**TOWN OF MOUNTAIN VILLAGE
REGULAR DESIGN REVIEW BOARD MEETING
THURSDAY MAY 2, 2019 10:00 AM
2nd FLOOR CONFERENCE ROOM, MOUNTAIN VILLAGE TOWN HALL
455 MOUNTAIN VILLAGE BLVD, MOUNTAIN VILLAGE, COLORADO
AGENDA**

TO: Design Review Board
FROM: Sam Starr, Planner
FOR: Meeting of May 2nd, 2019
DATE: April 24, 2019
RE: Consideration of a Design Review: Final Review application for a new single-family dwelling on Lot 165-13, 230 Cortina Drive.

Taten Residence
Lot 13 Cortina
Mtn. Village, CO

ADDRESS MONUMENT
 SCALE: 3/4" = 1'-0"

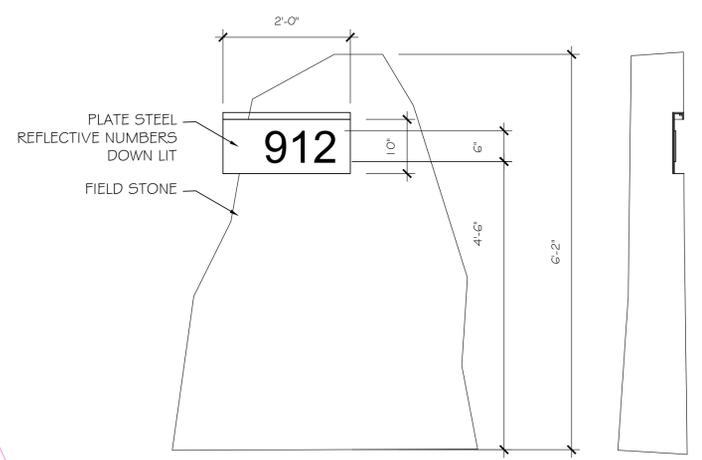
3. *Owners Applicant will need to adjust the address monument to make the address monument numbers downlit instead of backlit. Numbers will need to be coated with a reflective paint.*

The applicant will be using 10” plate steel box numbers attached to field stone. The address monument complies with the maximum height of 6 feet. The applicant has revised the monument since the Initial Architectural Site Review to include a LED ribbon downlighting system.

CONSTRUCTION MITIGATION PLAN

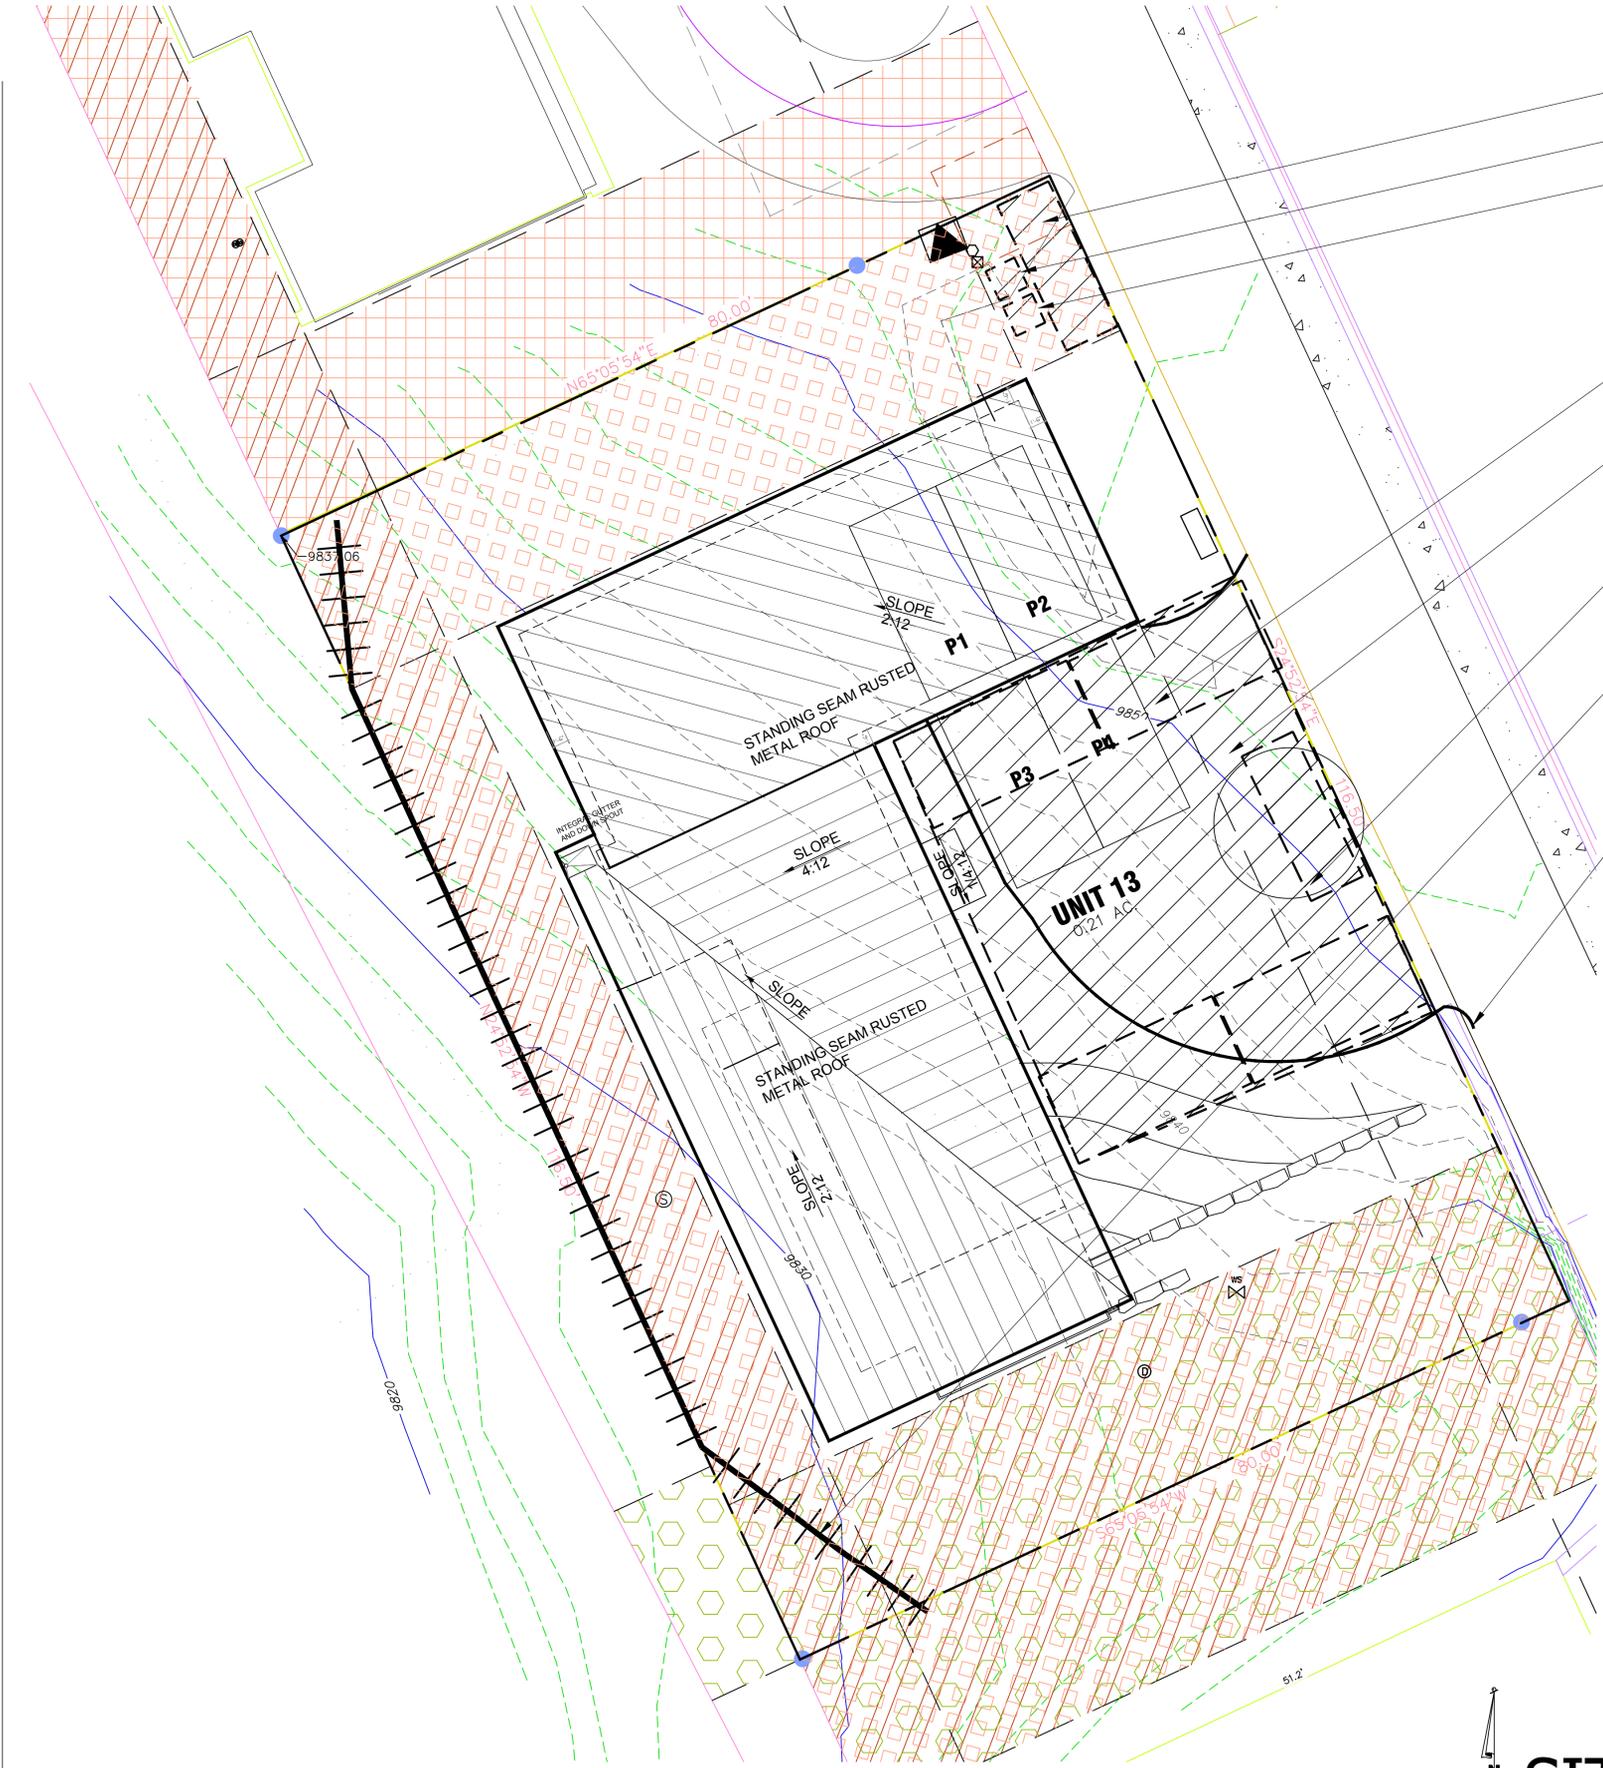
All construction staging is within the lot boundaries. However, the construction staging plan does show construction parking and disturbance in the area outside of the building envelope and in the Cortina Drive Right of Way. The HOA has approved the construction mitigation plan and would approve any construction mitigation plan as amended.

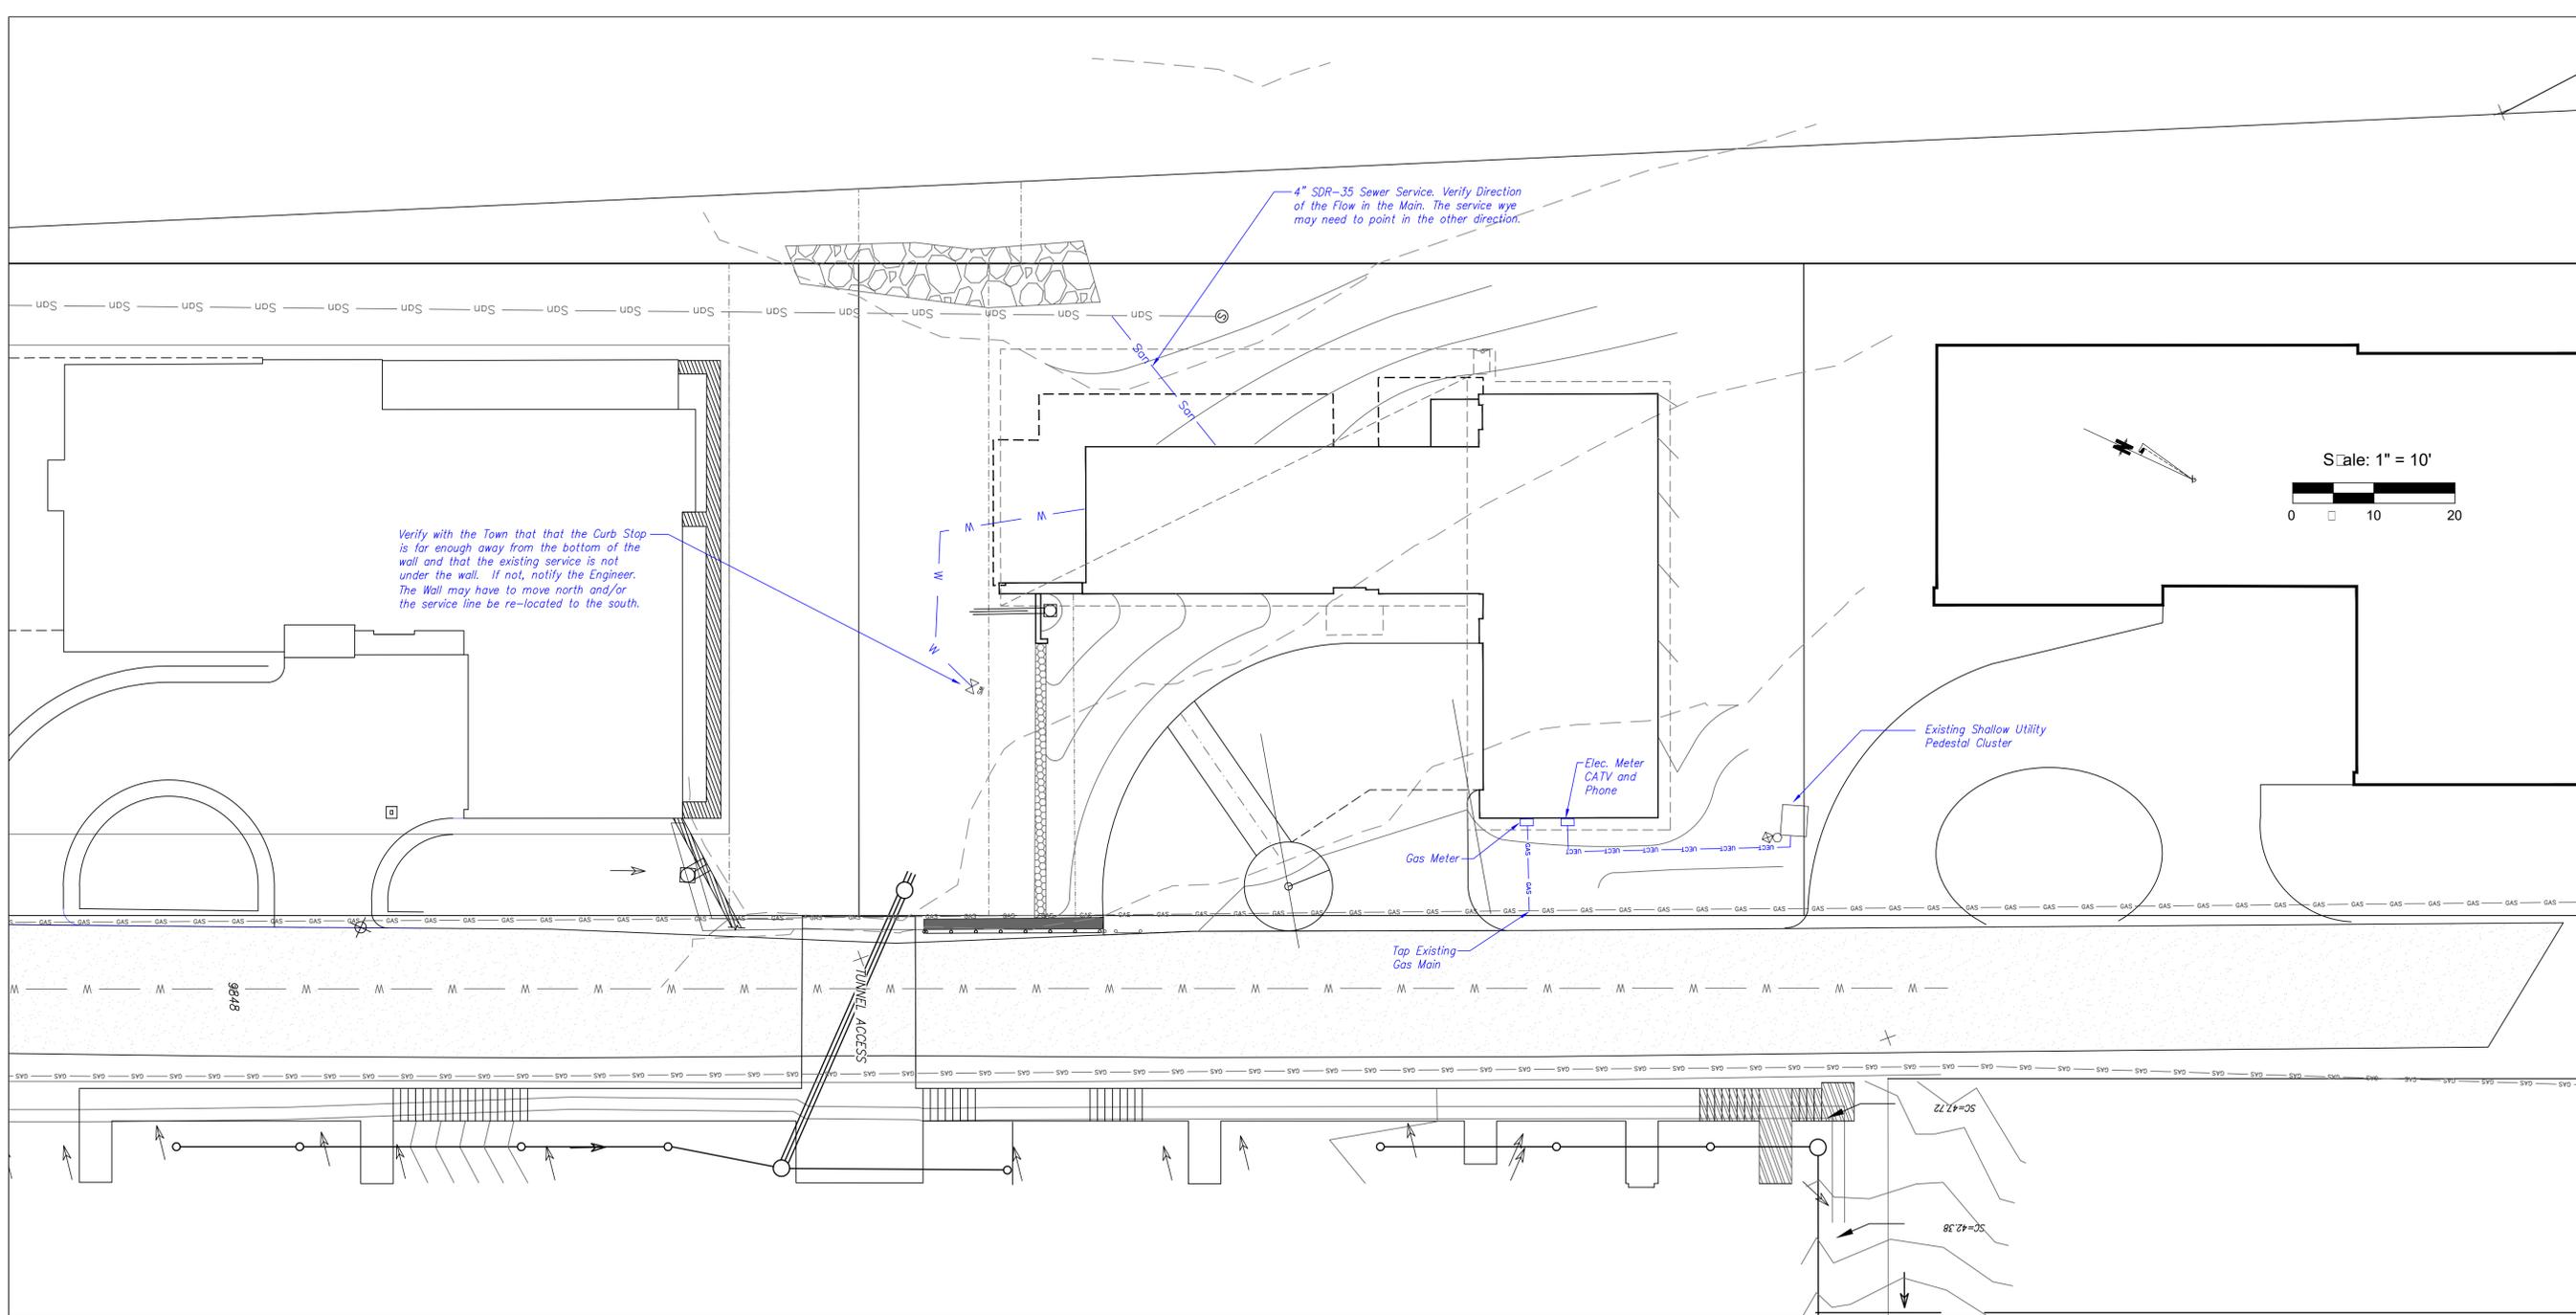
Verify with the Town that the Curb Stop is far enough away from the bottom of the wall and that the existing service is not under the wall. If not, notify the Engineer. The Wall may have to move north and/or the service line be re-located to the south.

4" SDR-35 Sewer Service. Verify Direction of the Flow in the Main. The service wye may need to point in the other direction.

Drawing
L1

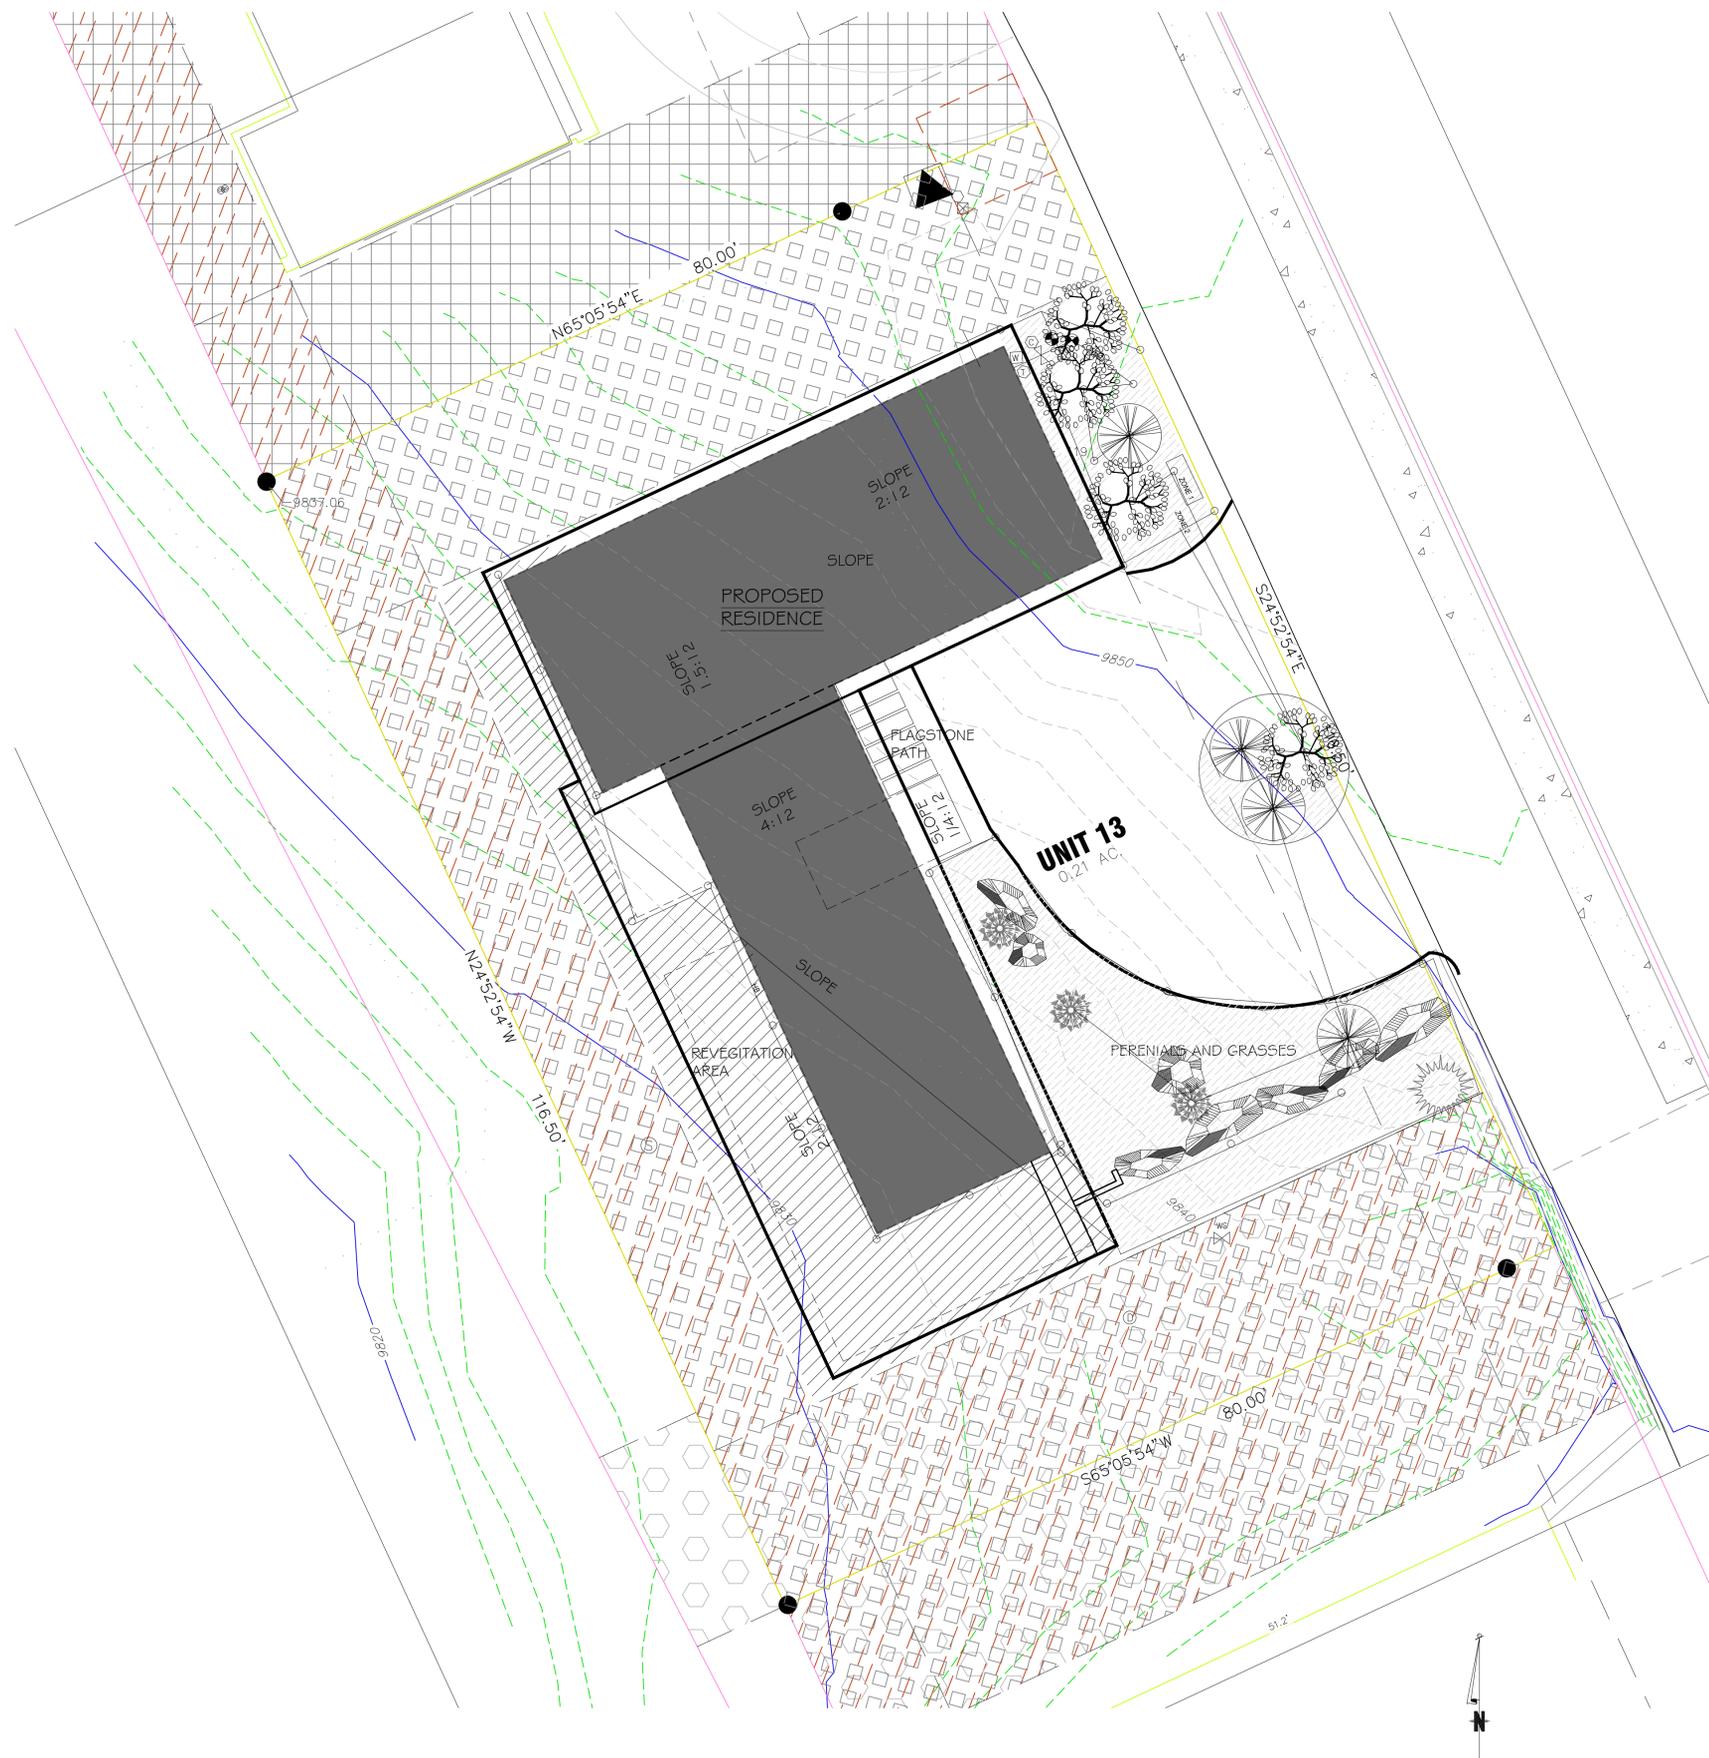
The proposed landscape plan shows the addition of 4 aspen, 4 bristlecone pine, 3 specialty spruce trees, and an assortment of perennials with native wildland grass. Additionally, there are landscaping elements in the setbacks outside of the building envelope area. All plantings shown on Final Review will need to be in compliance with Table 5-4 of the CDC:
